NEBRASKA ARMY NATIONAL GUARD
Wahoo Readiness Center Addition

PROJECT NO. 31030344

A D D E N D U M N O . 1

1 FIRST FLOOR TECHNOLOGY PLAN
 1/8" = 1'-0"

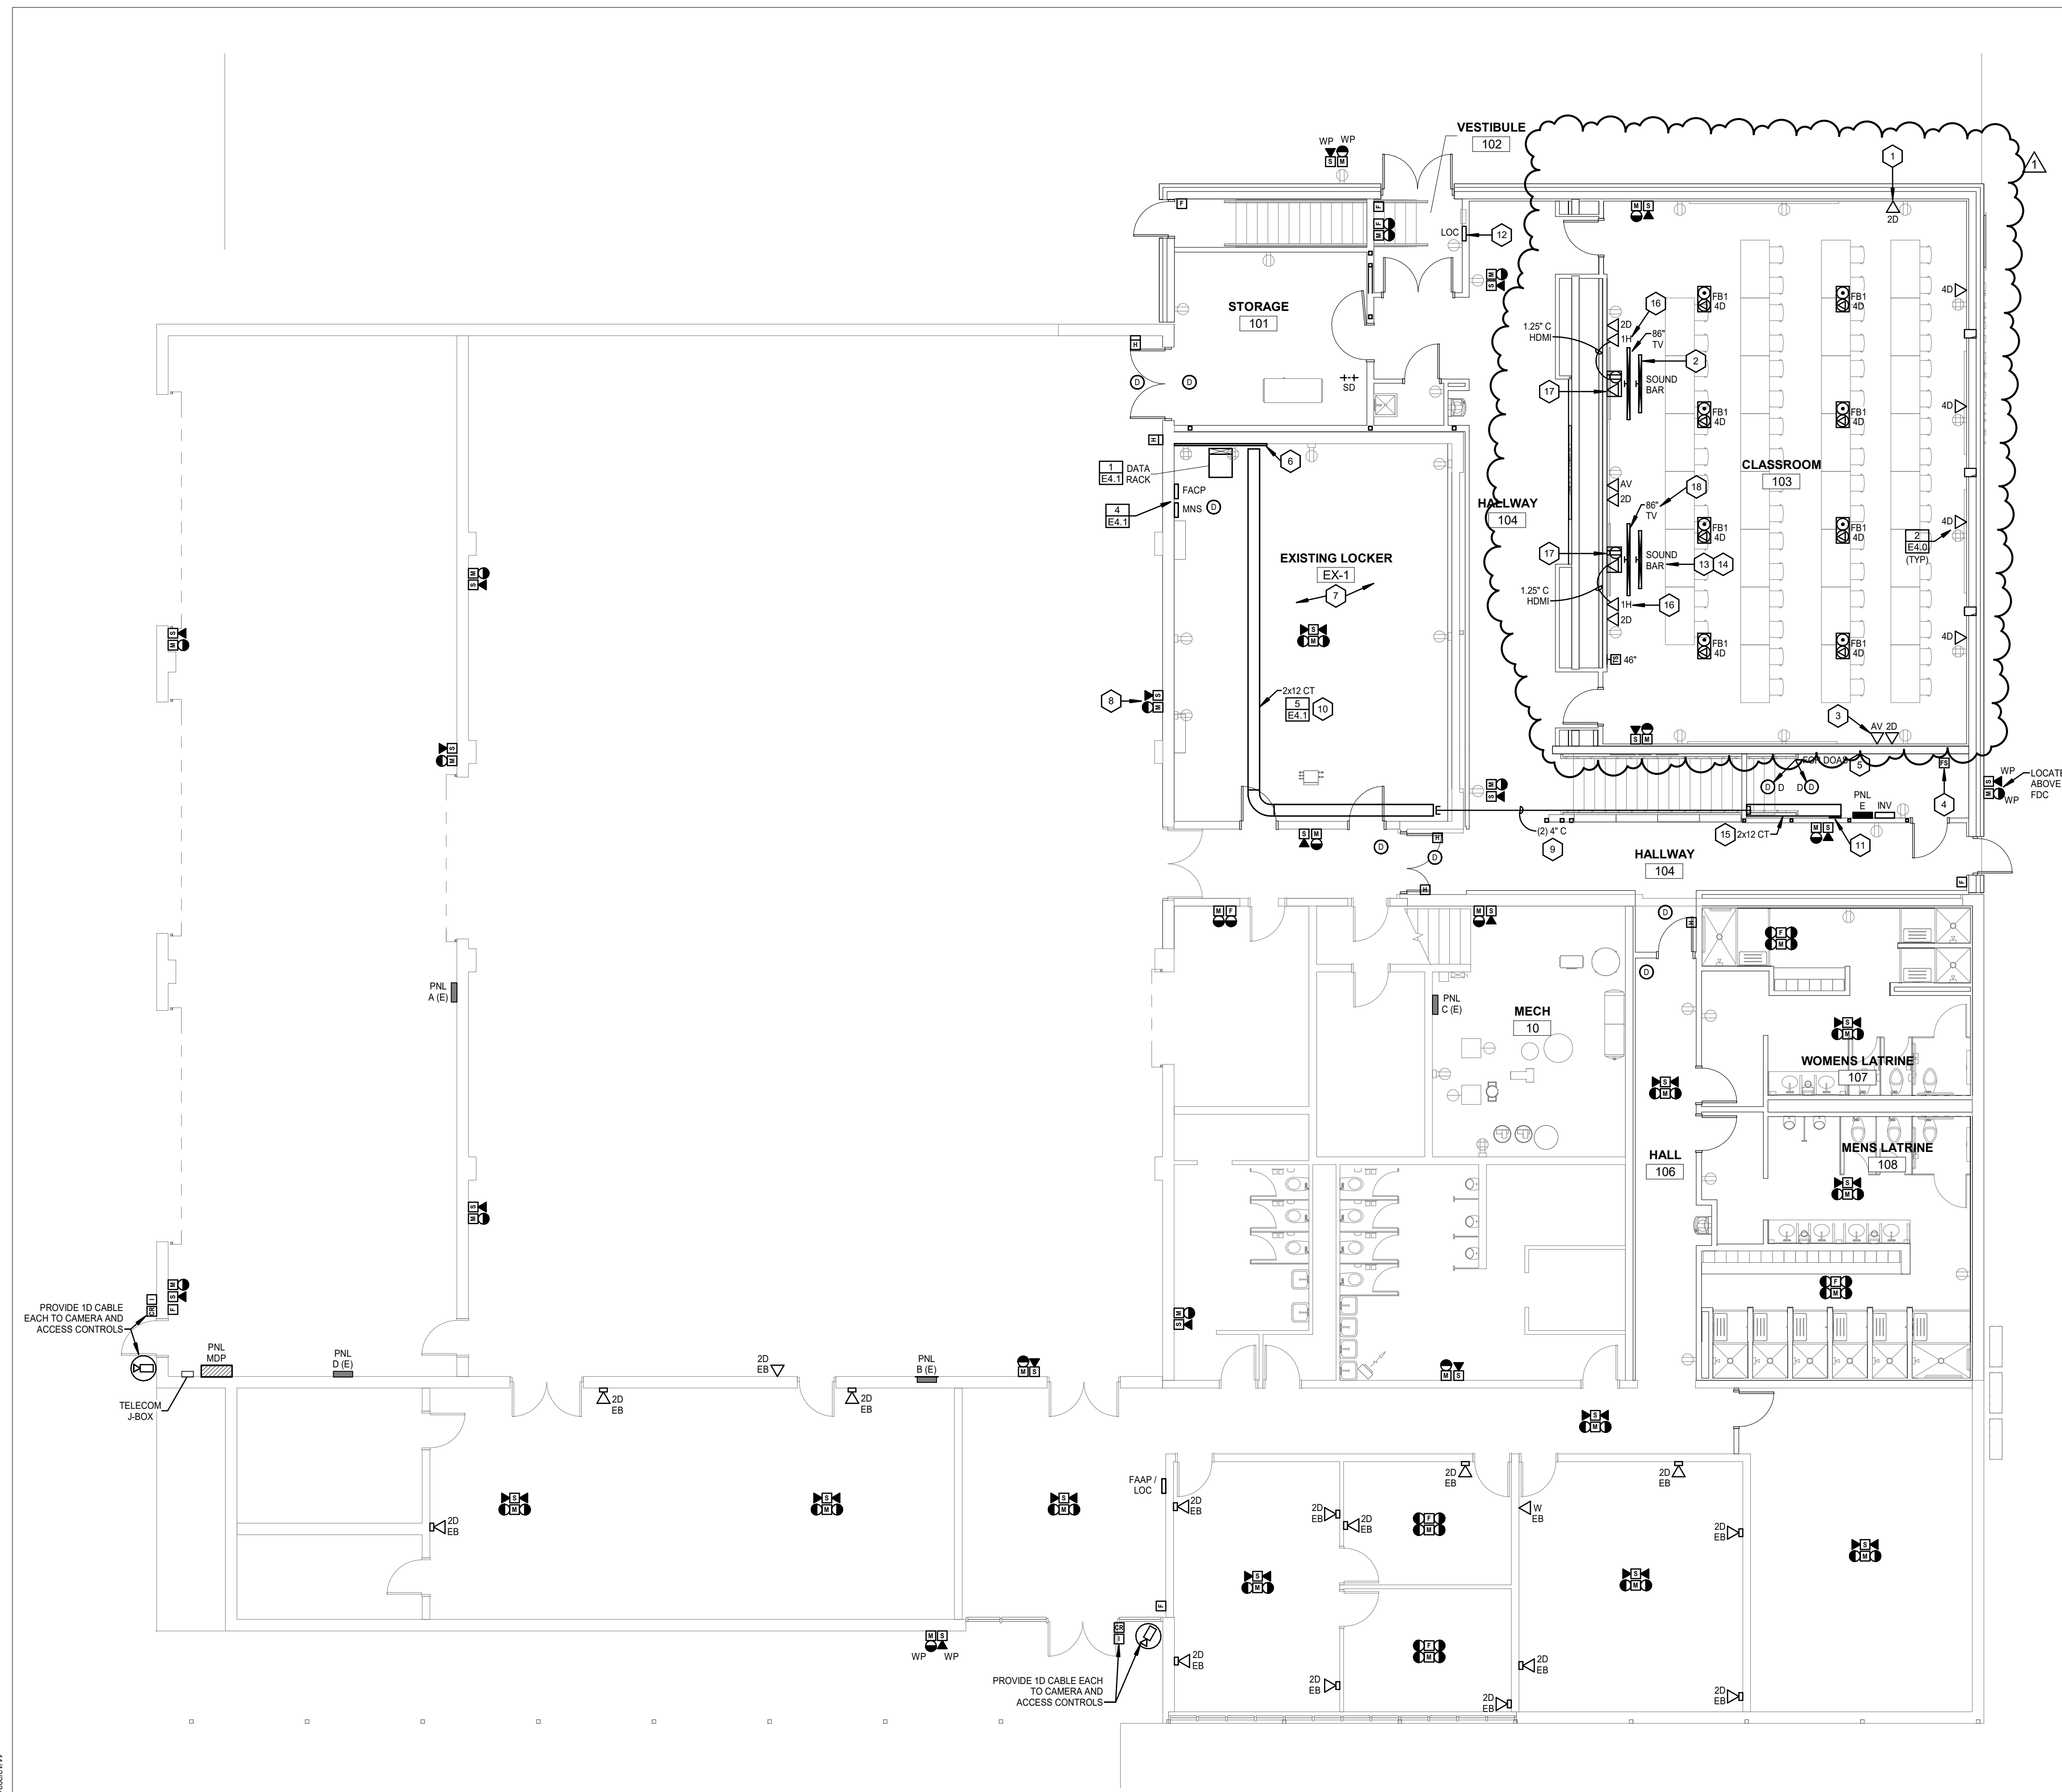
- b. Added Note 9 for wall box coordination.
- 11. Sheet E3.1 First Floor Technology Plan
 - a. Revised AV System requirements, including but not limited to: removing the AV Rack, revising cabling, revising AV equipment, and revising box requirements and locations.

- 13. Sheet E5.0 Electrical Schedules
 - a. Removed WB1 from Floor and Wall Box Schedule, WB1 requirements have changed and are now specified on Sheet E3.1.

3 AV SYSTEM DIAGRAM - CLASSROOM 103
 NO SCALE

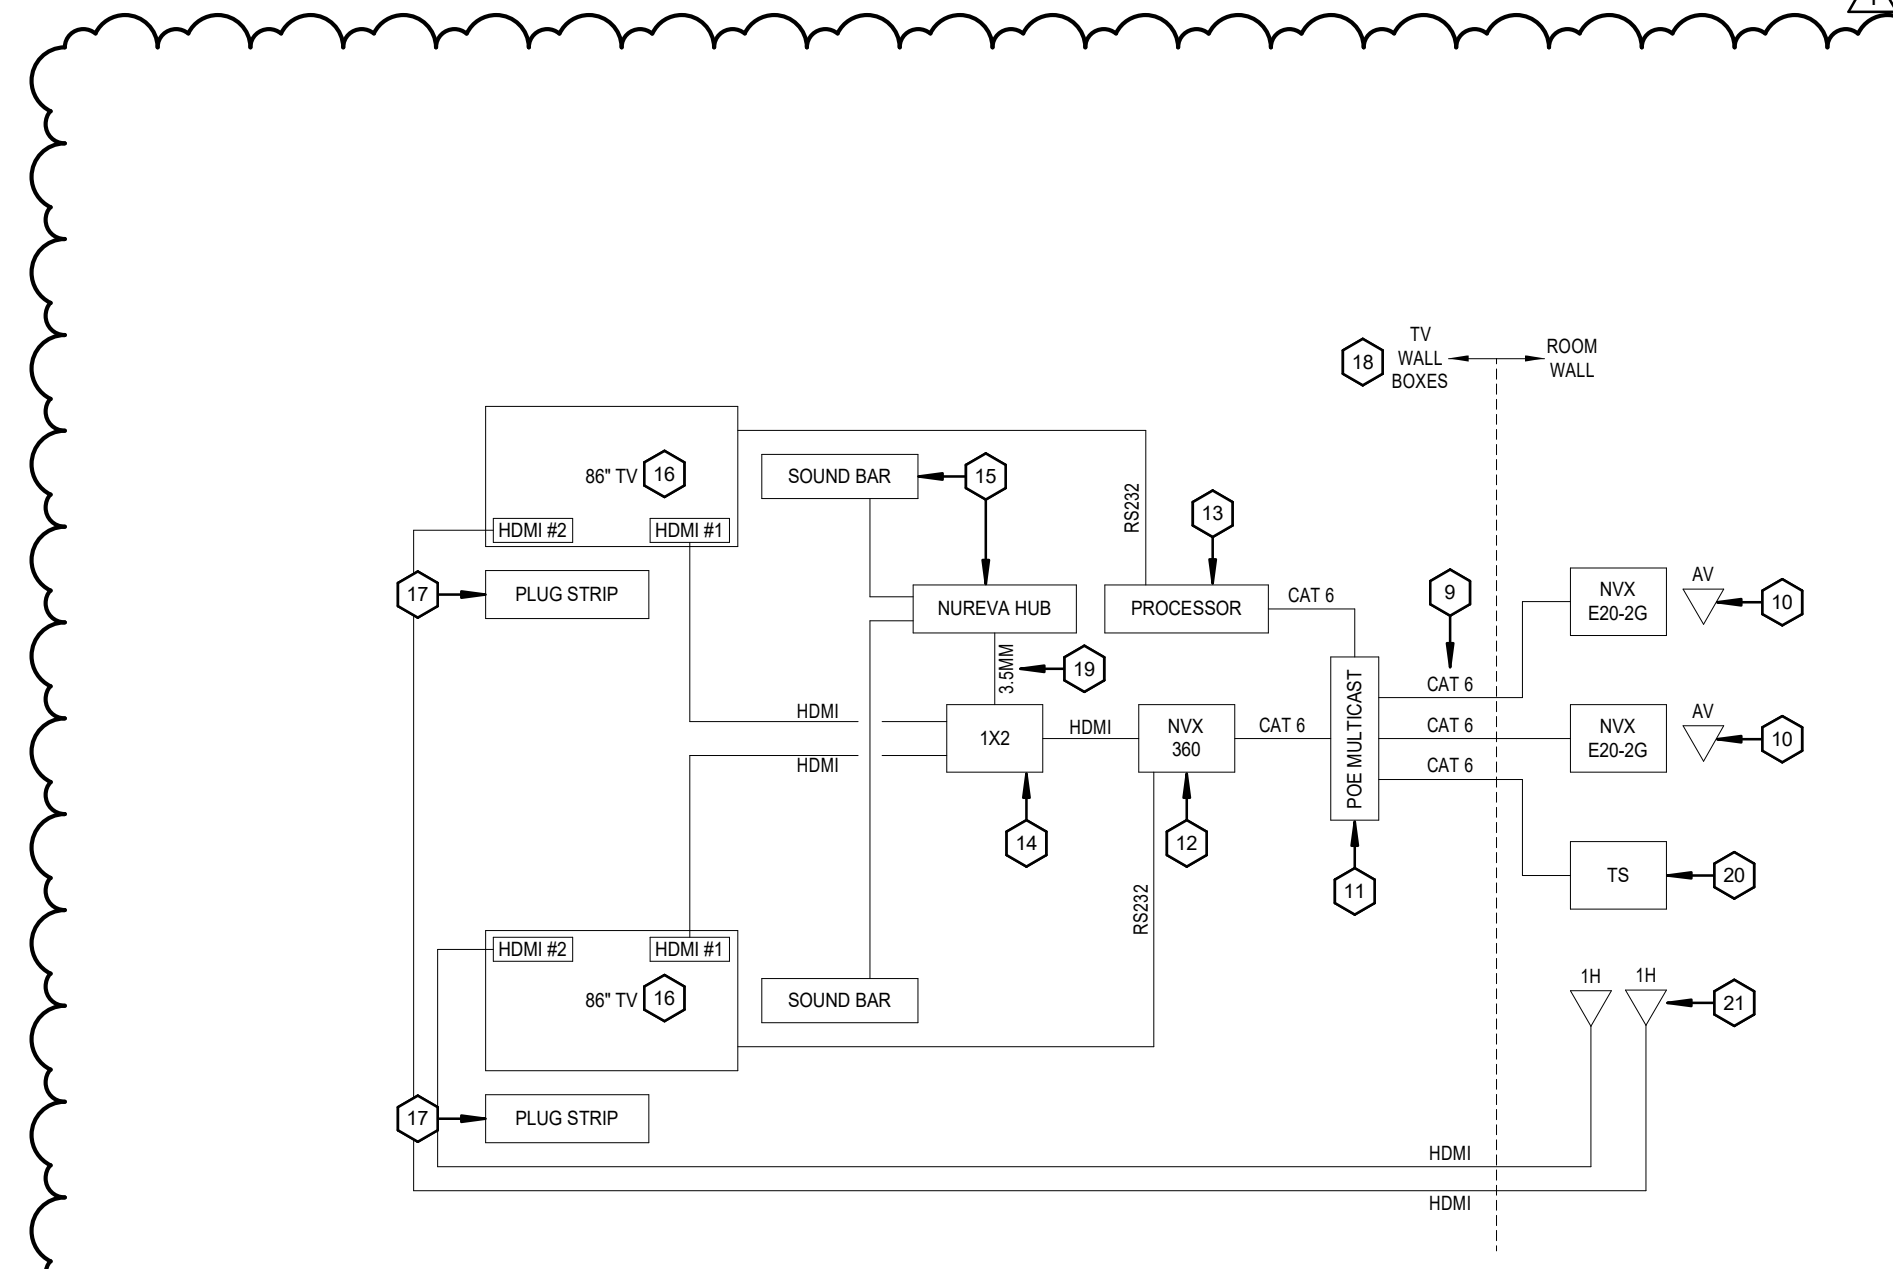
- 12. Sheet E4.1 Technology Details
 - a. Revised AV System requirements and specifications.
 - b. Removed AV Rack Elevation.
 - c. Revised Sheet Note order due to AV System revisions.
